CHAPTER - 34 HIGHLIGHTS (Summary of Changes)

Revision No. TR34-11 Sep 30/20

TO: HOLDERS OF THE AIRCRAFT MAINTENANCE MANUAL (06-123838)

**Circuit Breaker Locations
Figure 502 (Sheet 1 of 1)**

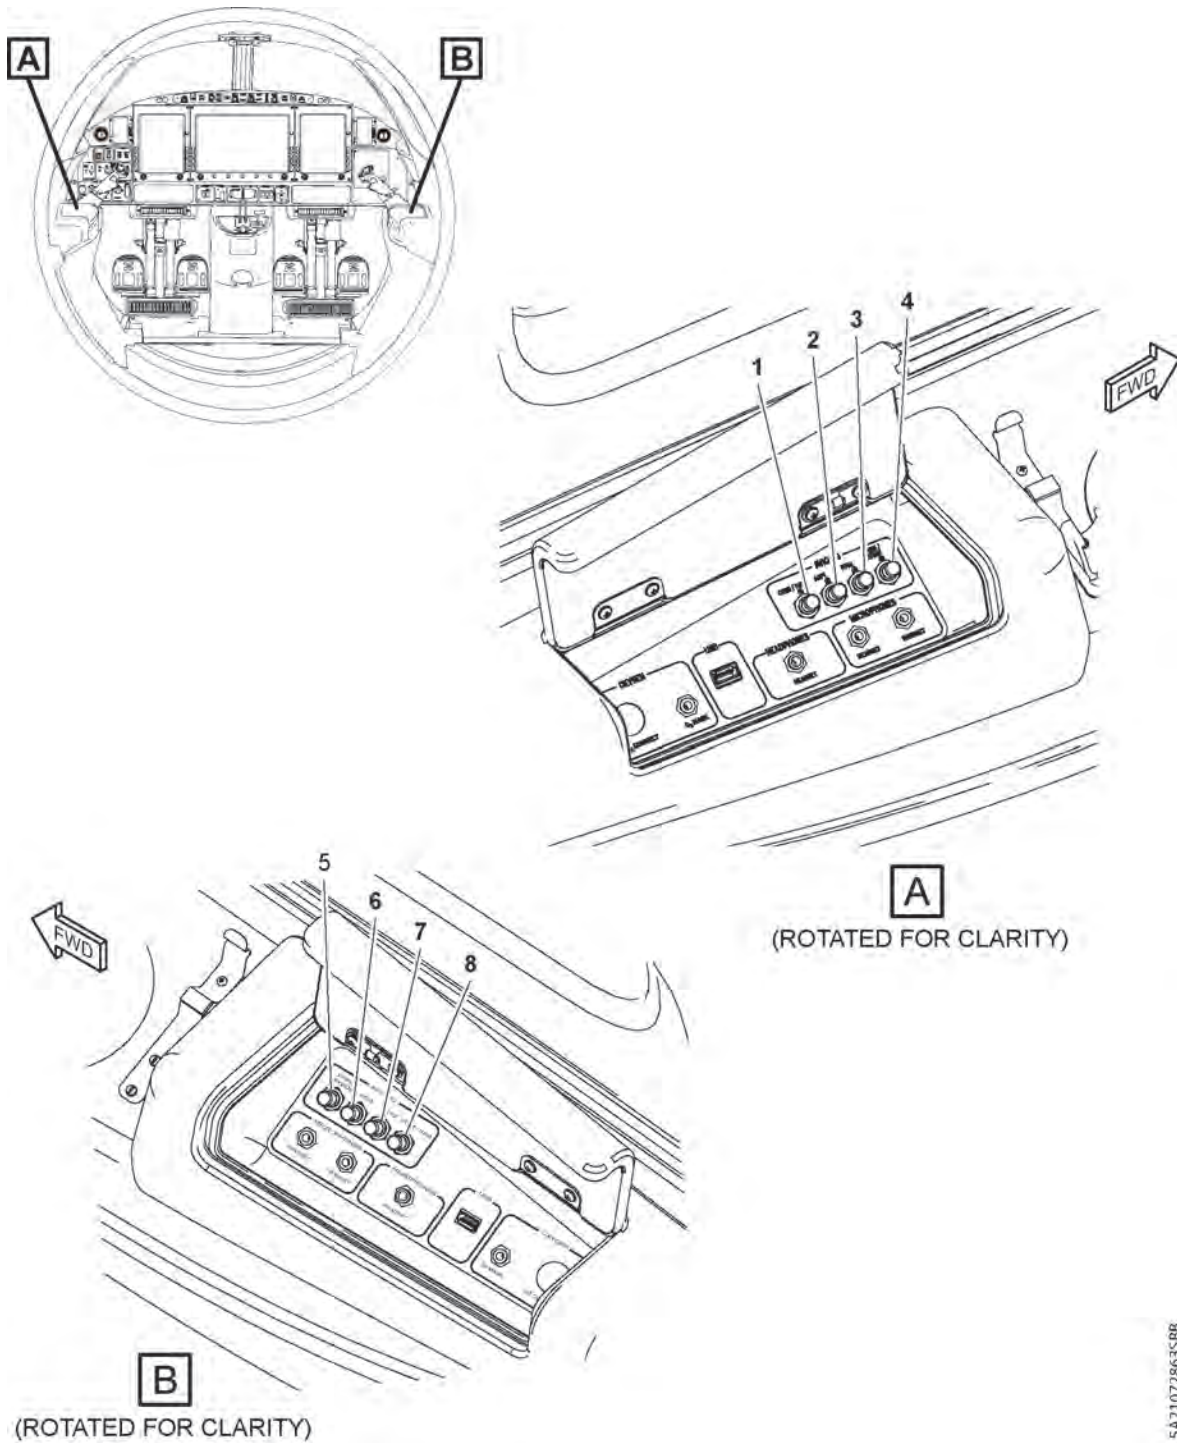
| CH/SE/SU Page Block No. | Description of Change |
|-----------------------------------|---|
| 34-50-24 PgBlk 501 | Adjustment/Test – Corrected circuit breaker labels. |
